# Access Compliance Report

## Public Rights-of-Way

| Intersection ID: 48473                  | Main Street: VOELTZ_DR | Cross Street: AUTUMN_OAK_DR             | Location: NE           |
| ADA ID: C3AD561F8073                    | Ramp Type: PerpDiag    | Initial Pass/Fail: Fail                 | Overall Compliance: No |

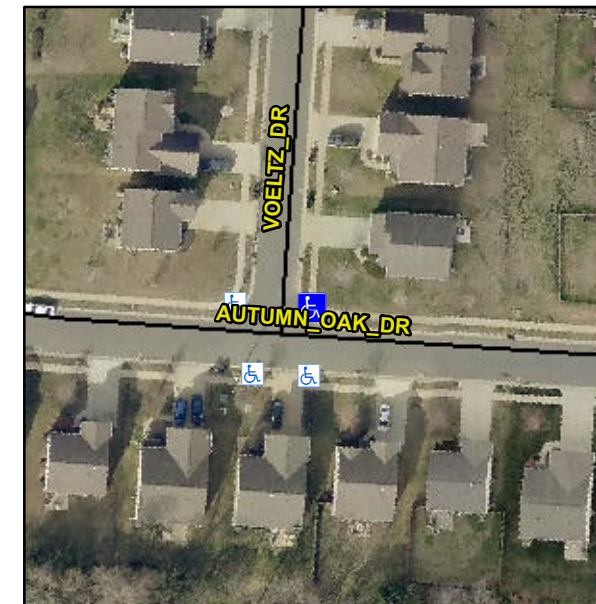
**Not Found, R304.5.1, R304.2.2, R304.5.3**

| Compliance | Description           | Data | Compliance | Description                 | Data |
|------------|-----------------------|------|------------|-----------------------------|------|
| N/A        | Ramp Length (in)      | 48.0 | No         | Ramp Slope (%)              | 12.2 |
| No         | Ramp Width (in)       | 46.0 | No         | Ramp XSlope (%)             | 3.1  |

**Remove & Replace Curb Ramp With Two New Directional Ramps or Equivalent.**
